Service Information

S. I. No. - IND 82/001

Applicable to : W 220

Prevention of non functioning of antenna

Welding burr on roof panel

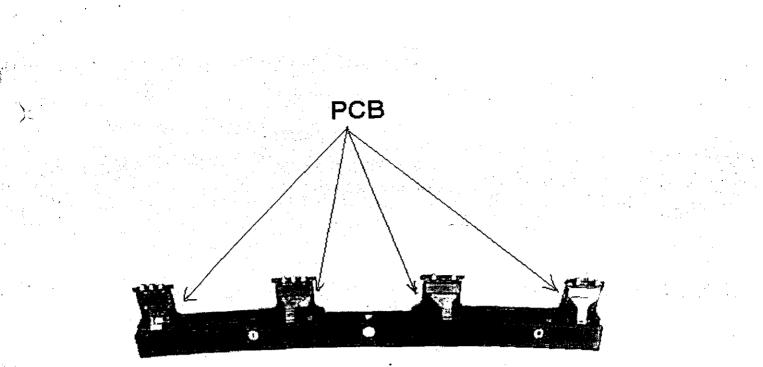
Antenna may non-function because of the antenna PCB getting cut/ short circuited due to welding burr noticed on roof panel where Antenna is fitted (please refer enclosed pictures).

In order to prevent this, the self sticking felt (minimum 5 mm thickness) is required to be added on the body above all the four Antenna PCBs. The working instructions are given below :

- 1. Remove both 'C' pillar
- 2. Remove rear roof handle
- 3. Remove clips of rear roof
- 4. Pull down the roof from rear side (It has Velcro on the roof and body panel)
- 5. Now remove antenna
- 6. Apply felt on body (Felt location should be above the 4 PCB's of Antenna)
- 7. Re-assemble the parts back
